Road Department

ADDENDUM NO. 1

CONSTRUCTION OF THE POWELL BUTTE HIGHWAY ROUNDABOUT

LANDSCAPE
GRADING PLAN

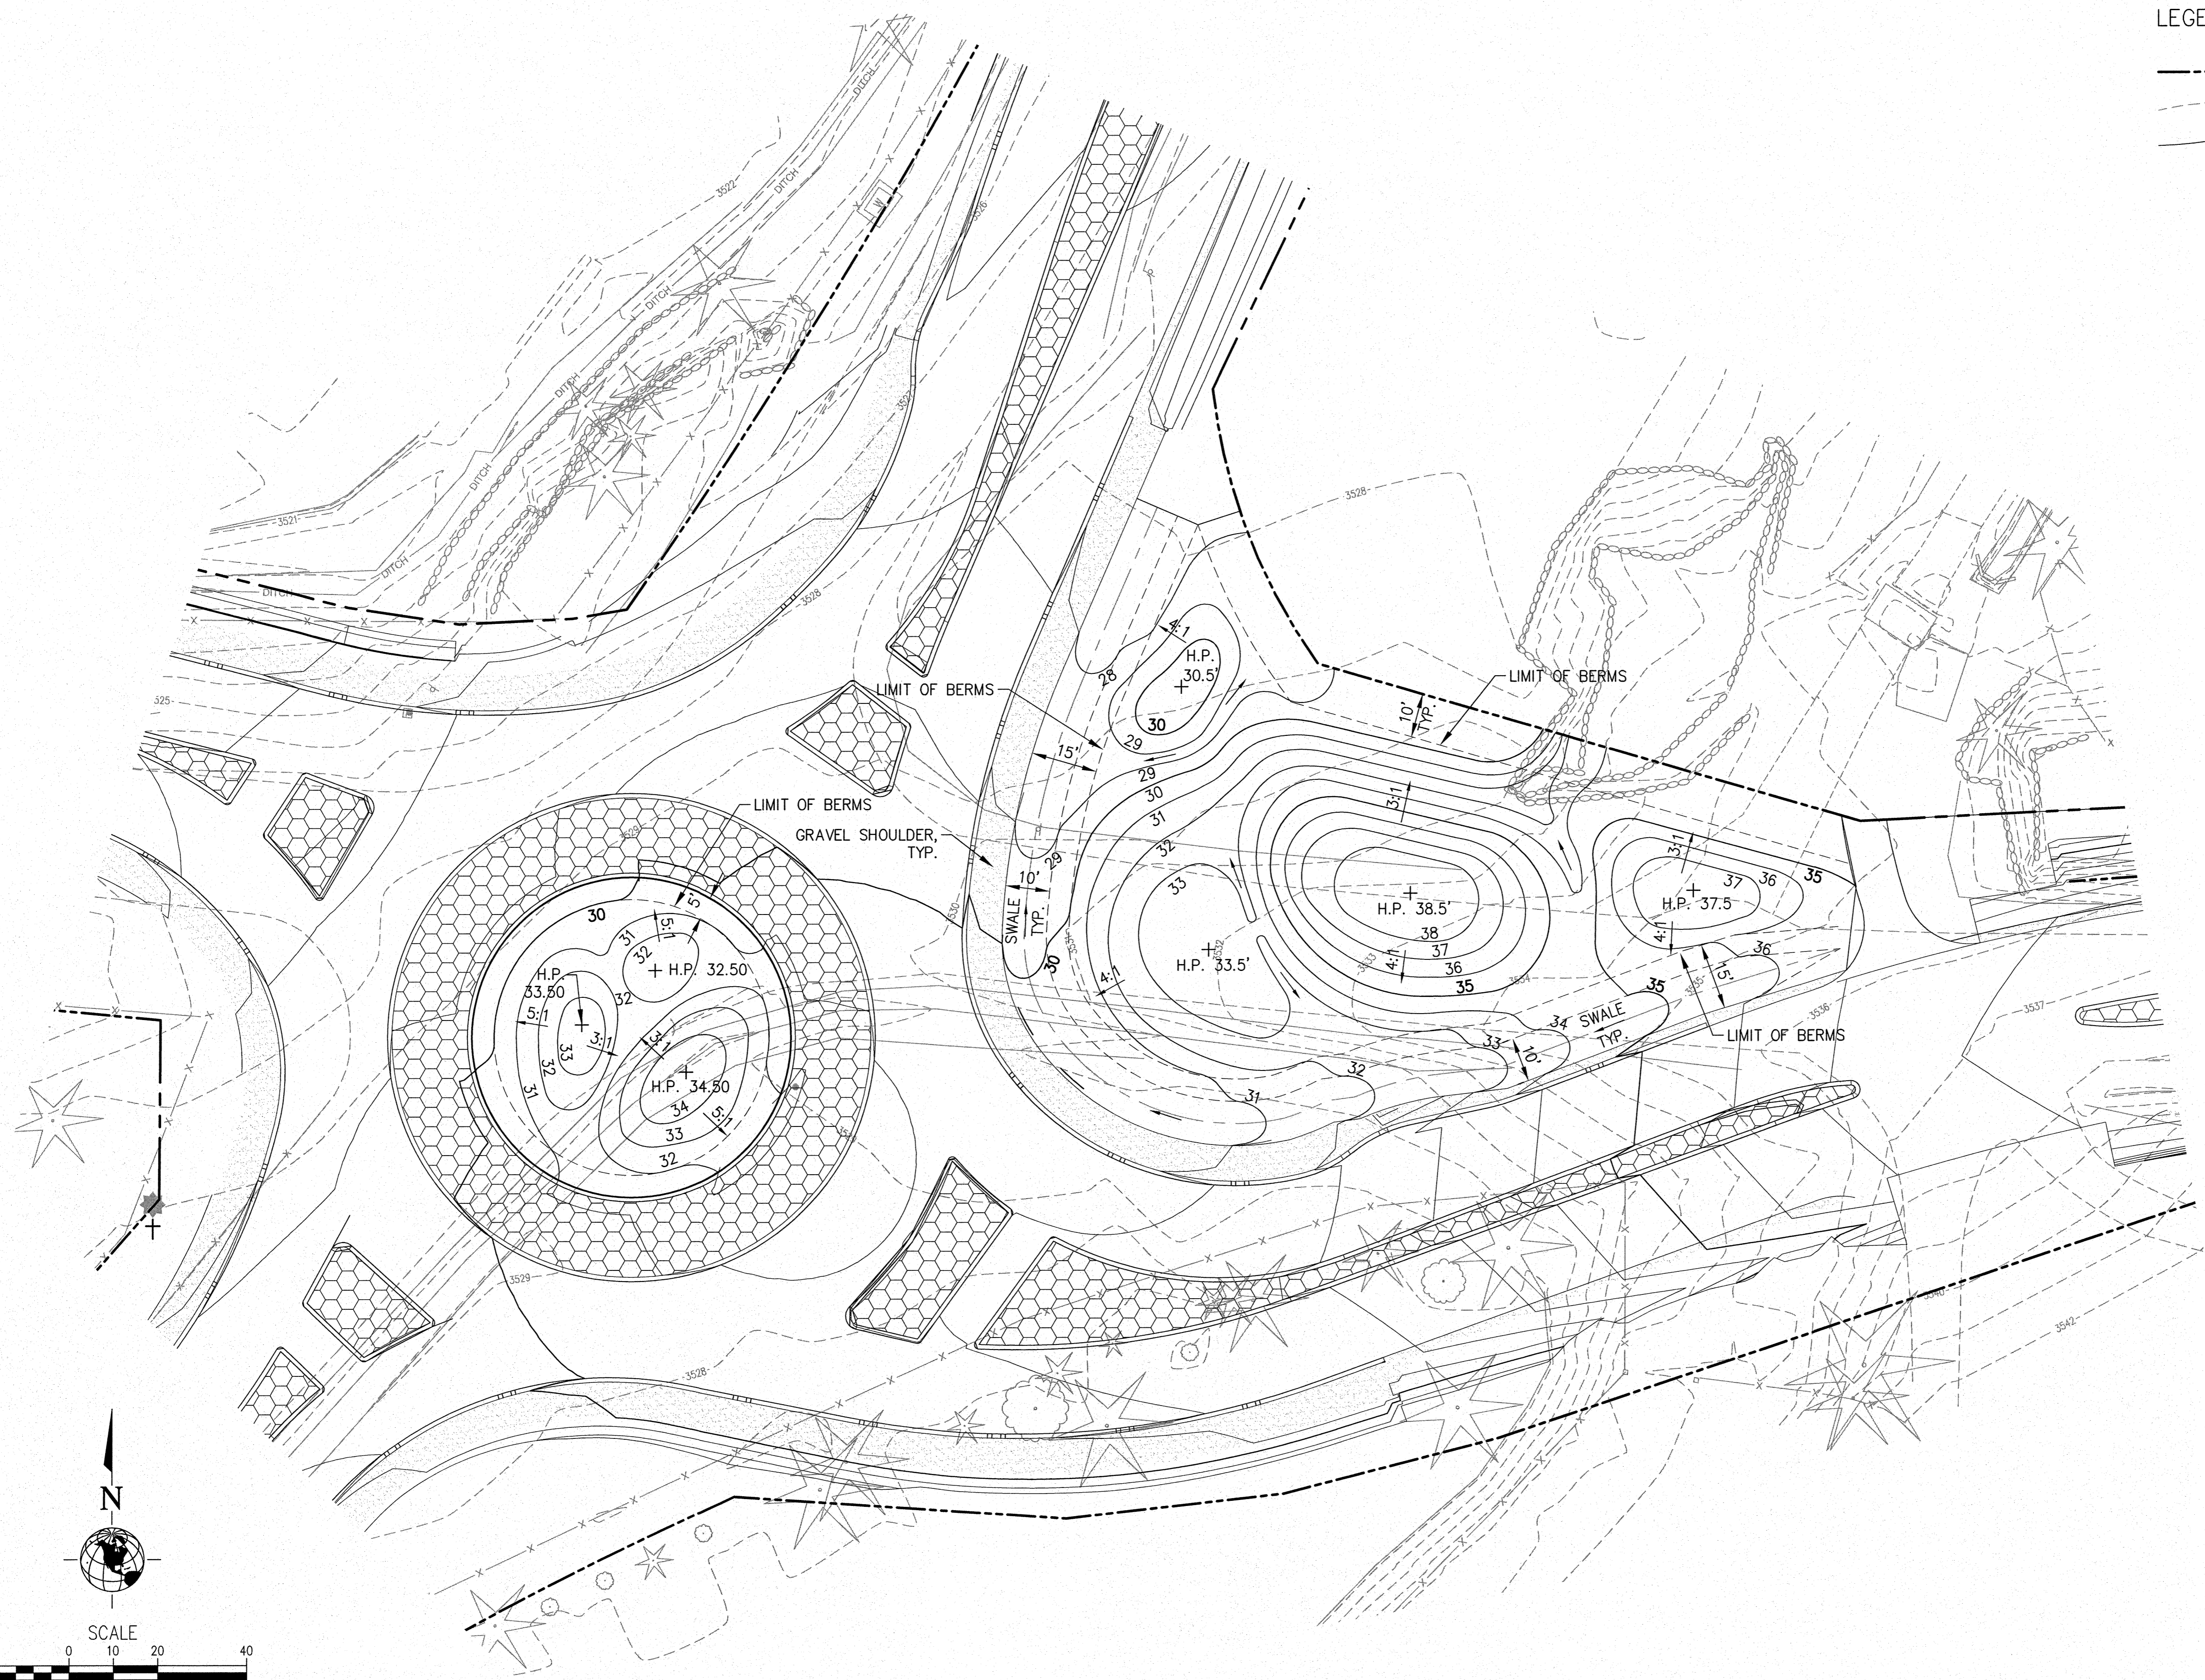
- Excavation quantities noted in Special Provision Section 00330.81 include all existing materials. Existing pavement material quantities have not been removed from the total volumes.
- Contractor shall comply with Special Provision Section 0A596.31 – Manufacturer's Representative Qualifications and Duties
- A cleaner PDF version of Sheet L1.2 is attached for clarity on the earthwork required for the mounding shown by existing and proposed contours.

ILLUMINATION PLAN

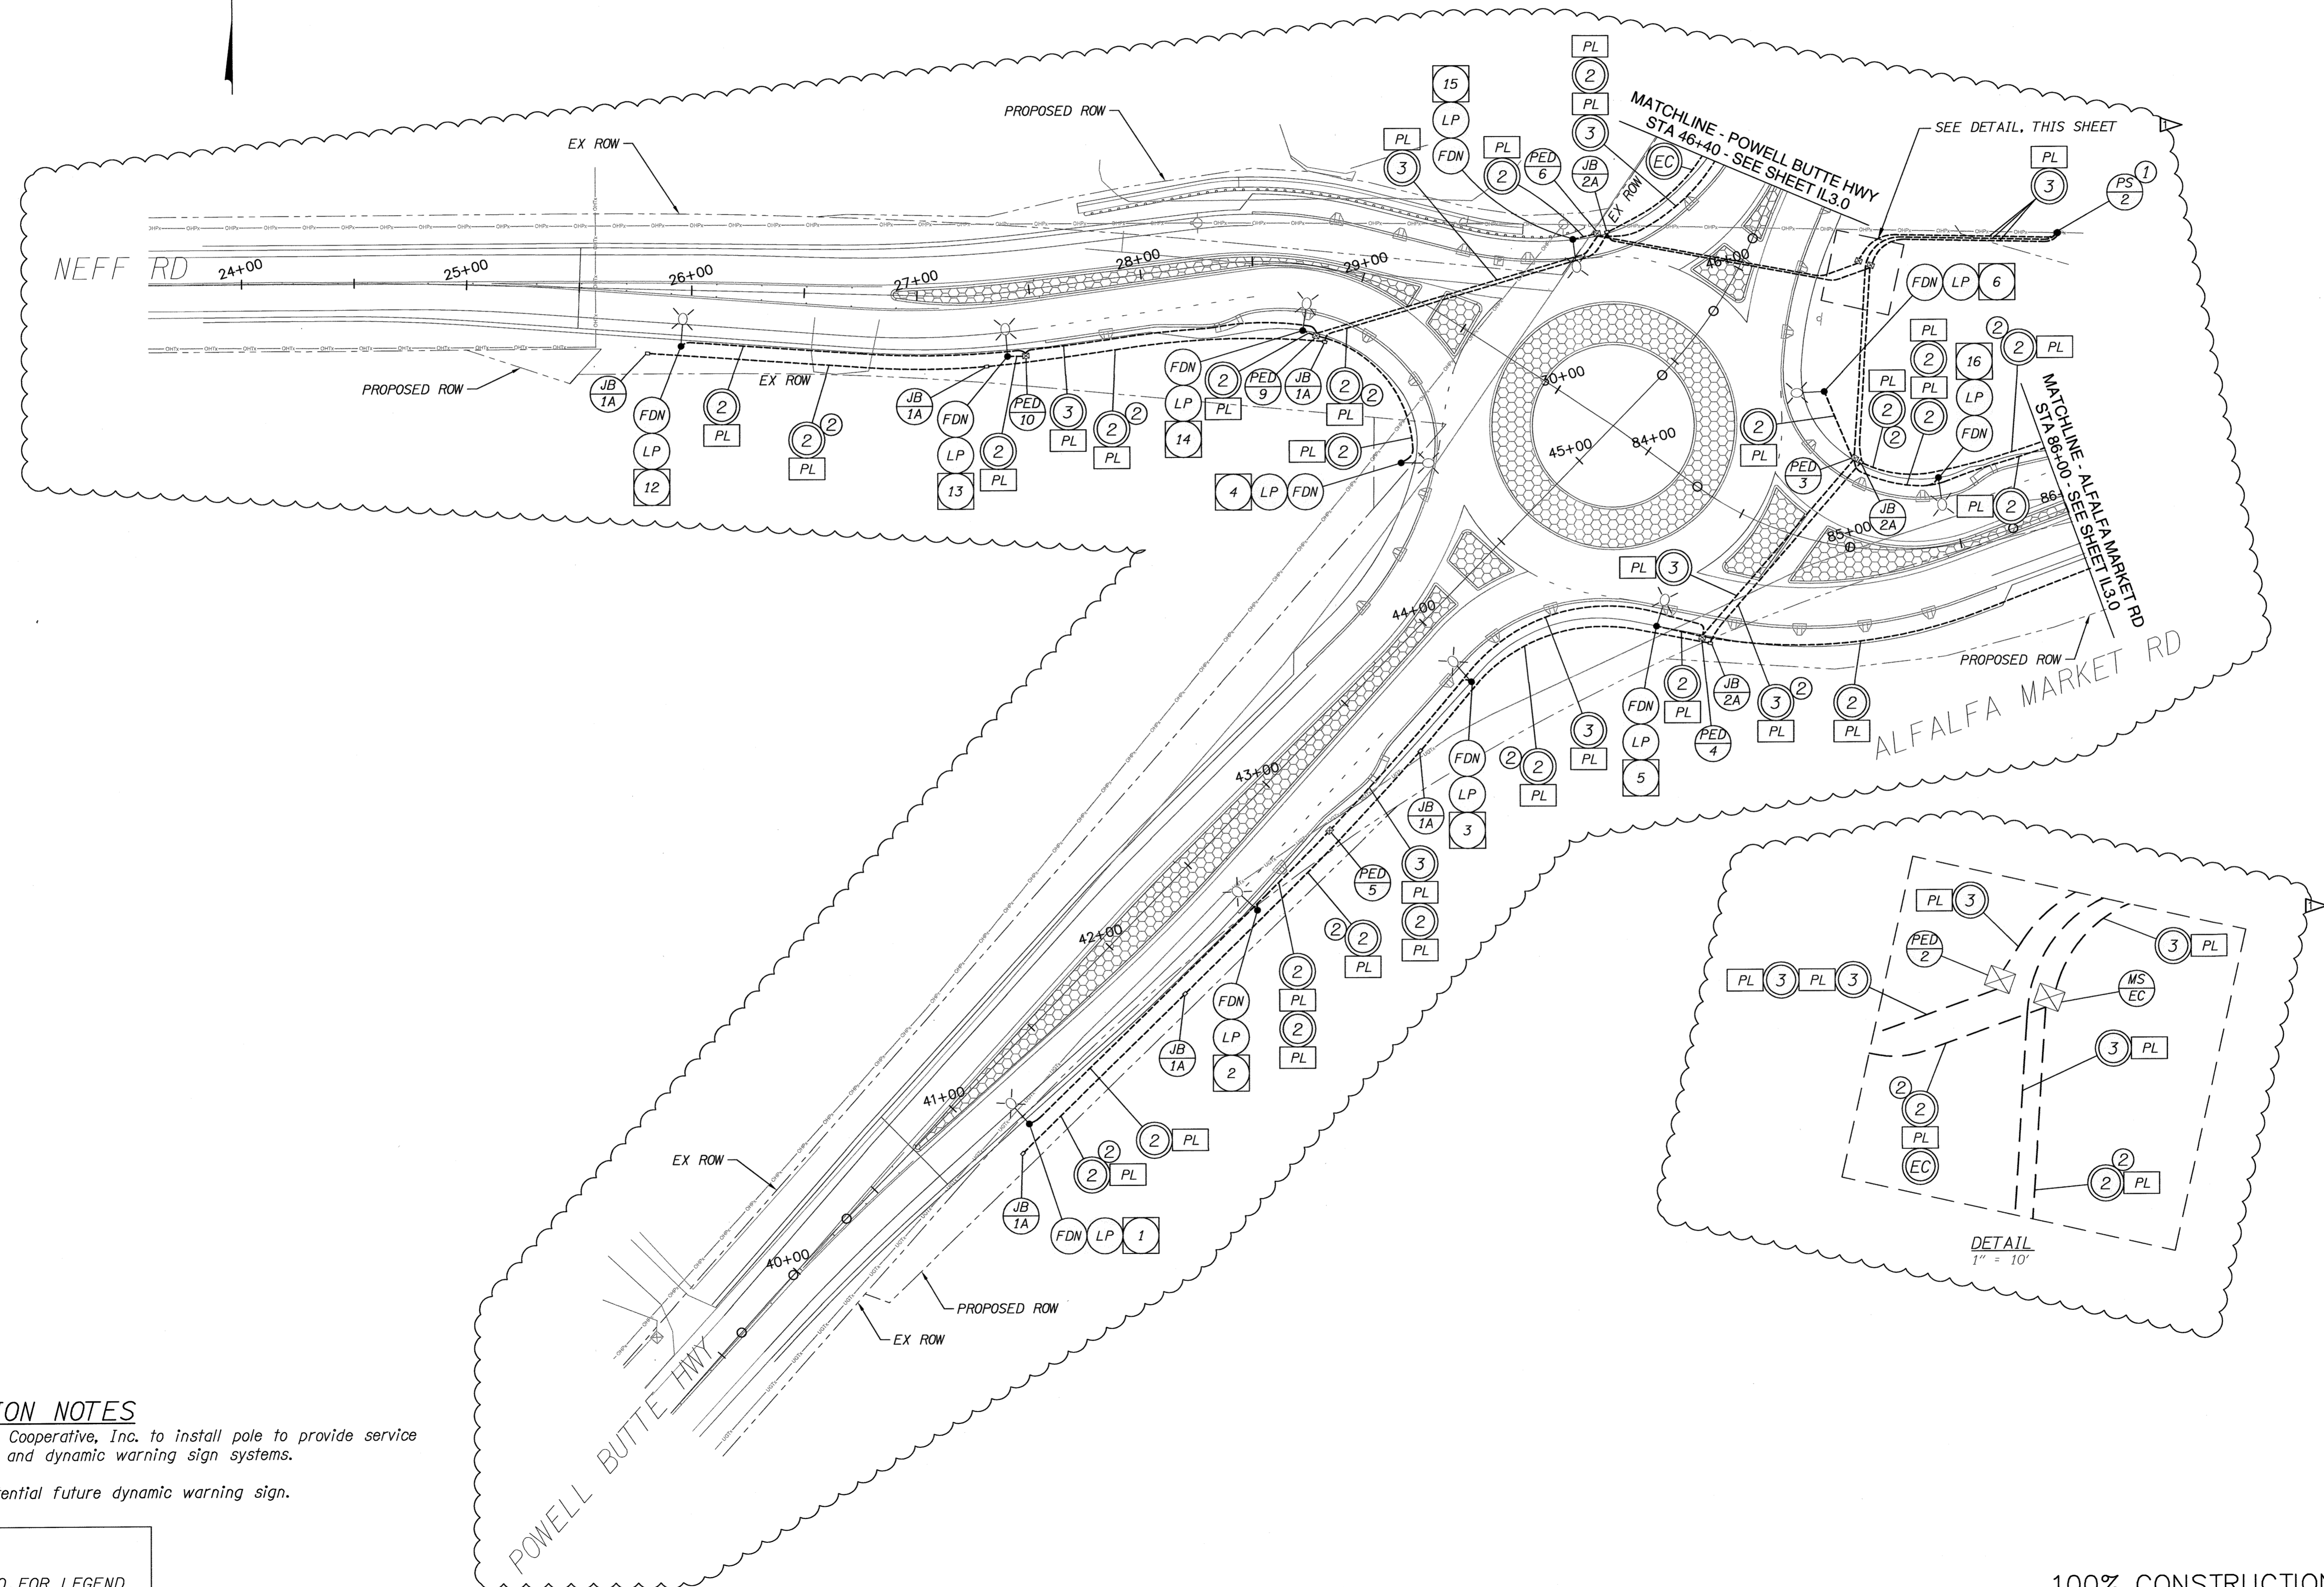
- a. Plan has been updated to reflect changes to conduit layout requested by Central Electric Cooperative. All service cabinets identified on the IL sheets have been removed and replaced with pedestals to be installed by Central Electric Cooperative. All conduit for potential future dynamic warning signs will be installed through junction boxes. All conduit for the street lighting system will be laid and stubbed at locations shown for pedestal installation by Central Electrical Cooperative. Where possible, the same trench should be used for conduit associated with both systems. See revised sheet in plan addendum. *Note: The*

metered service called out on Sheet 41 (ES1.0) remains in the plan and will be provided and installed by the Contractor.

- b. The 6'x4'x4' vault previously shown in the plans has been deleted and replaced with a pedestal to be installed by Central Electric Cooperative. See revised sheet in plan addendum.
